**STAFF REPORT
DEVELOPMENT COMMISSION
ZONING MEETING
CITY OF COLUMBUS, OHIO
DECEMBER 8, 2016**

1. **APPLICATION:** **Z16-060**
 Location: **5800 CENTRAL COLLEGE ROAD (43054)**, being 4.81± acres located on the north side of Central College Road, 310± feet east of Harlem Road (010-283214; Rocky Fork Blacklick Accord).

Existing Zoning: R, Rural District.
 Request: CPD, Commercial Planned Development and PUD-4, Planned Unit Development Districts.

Proposed Use: Daycare and single-unit dwellings.
 Applicant(s): Paul Cugini, Cugini & Capoccia Builders, Inc.; c/o David Perry, David Perry Company, Inc., Agent; 423 East Town Street, 2nd Floor; Columbus, OH 43215; and Donald Plank, Atty.; Plank Law Firm; 423 East Town Street, 2nd Floor; Columbus, OH 43215.

DEVELOPMENT PLAN

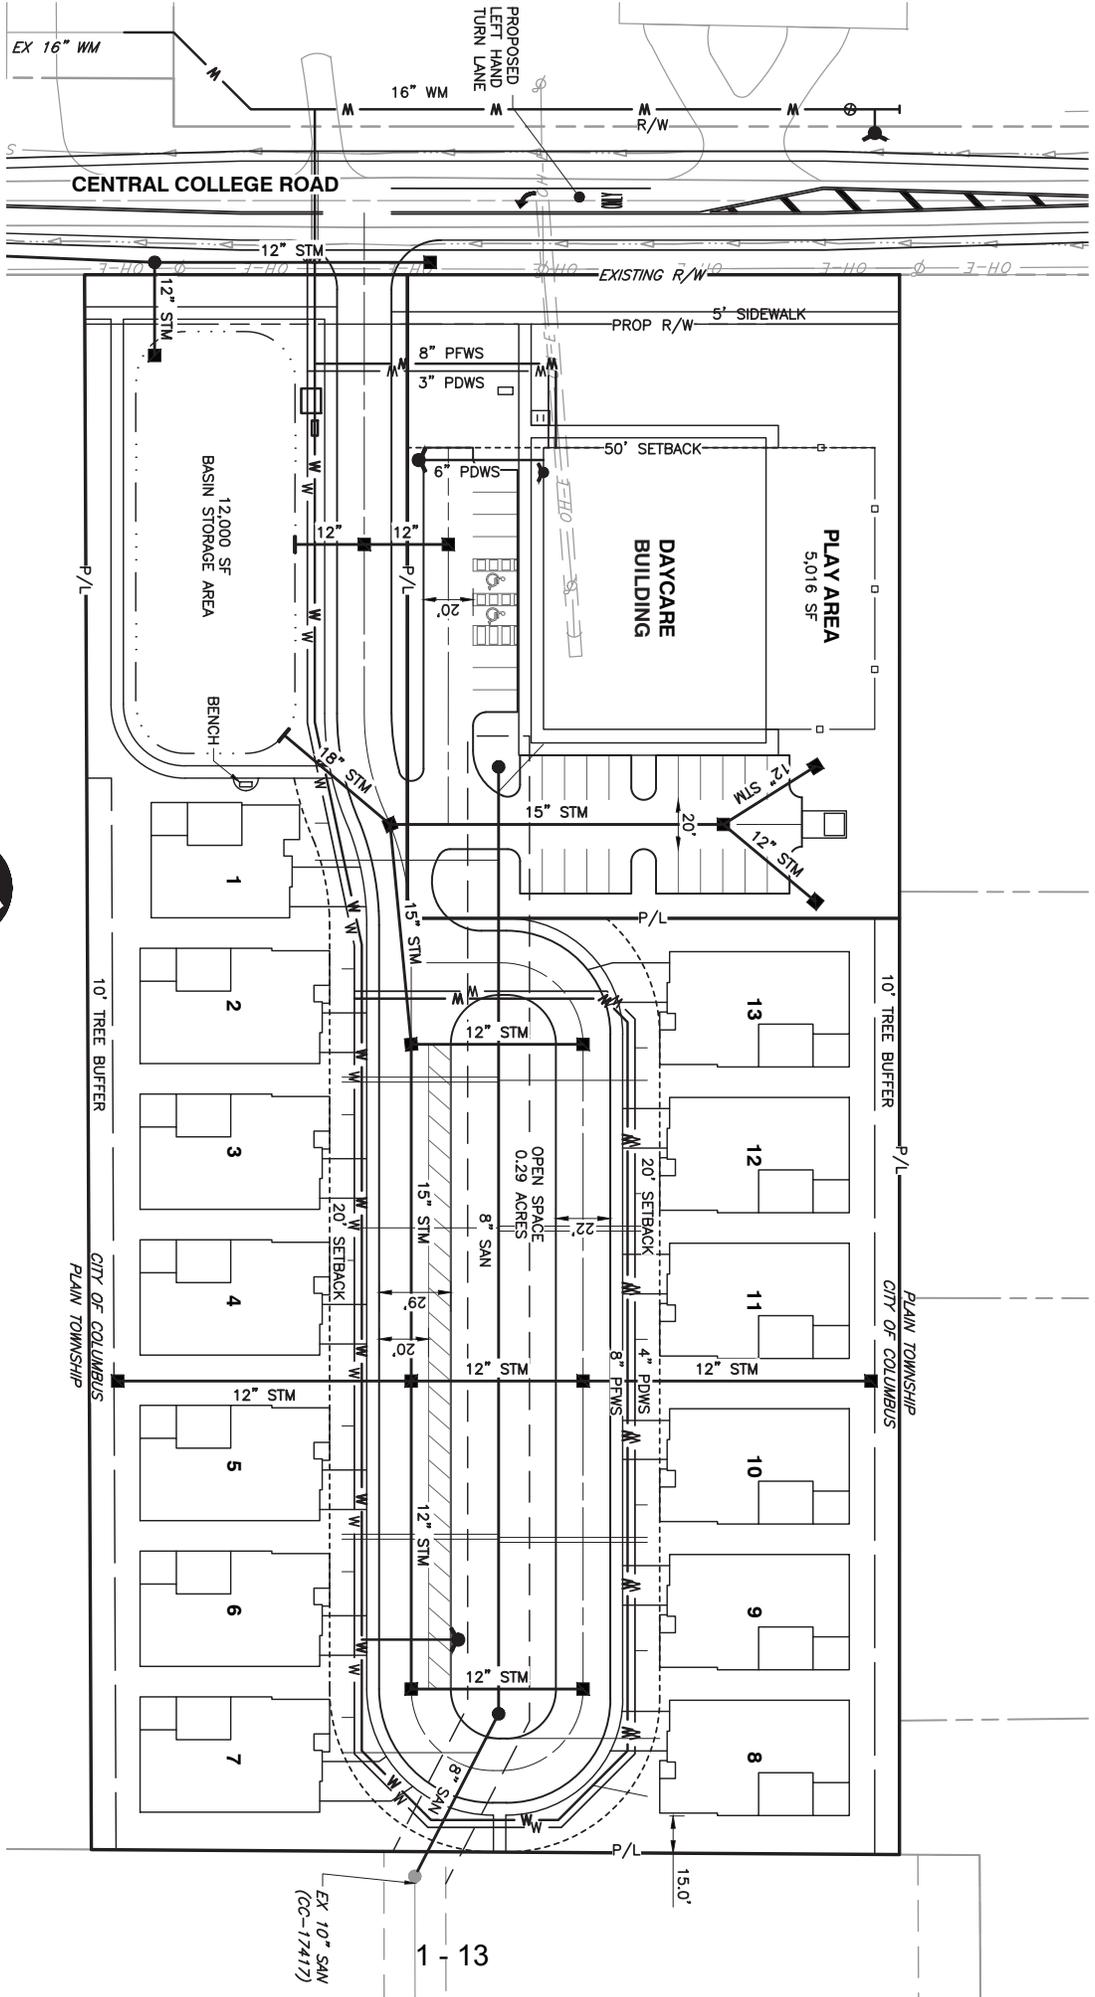
Mr. Paul asked for confirmation on the location of the playground area for the childcare center. He asked for further elaboration about traffic and drop-off area.

Ms. Briggs asked if staff has accounted for the required number of parking spaces provided.

Ms. Briggs expressed concern about the provision for adequate parking for turn-around and drop-offs.

Mr. Chappellear said they should consider providing a curb cut in the median to improve circulation.

Ms. Briggs agreed with the suggestion saying it appears the site could bottleneck as laid out now.

Ms. Burton commented that she likes the mix of uses and using the daycare as a buffer. She expressed concern about the access point to the daycare being close to Central College. She suggested that a curb cut would help with the site's flow and queuing. She requests that the applicant provide screening for building 1 from the daycare if they provide the curb cut. She added that the applicant also change grade to block headlights from cars. Her initial concern with the lack of open space has been alleviated since the developer is marketing the development for empty nesters and there won't be many kids in the neighborhood.

Mr. Cugini said he doesn't foresee drop-off being a problem.

Mr. Perry stated that there are 31 total spots and that most users will be picking up and dropping off and not parking for a long period of time. He added that 31 spaces currently exceed code requirement.

Ms. Briggs moved to approve the application with note that a license traffic engineer to examine the need for a turn lane, seconded by Mr. Paul. Motion passed 5-0.
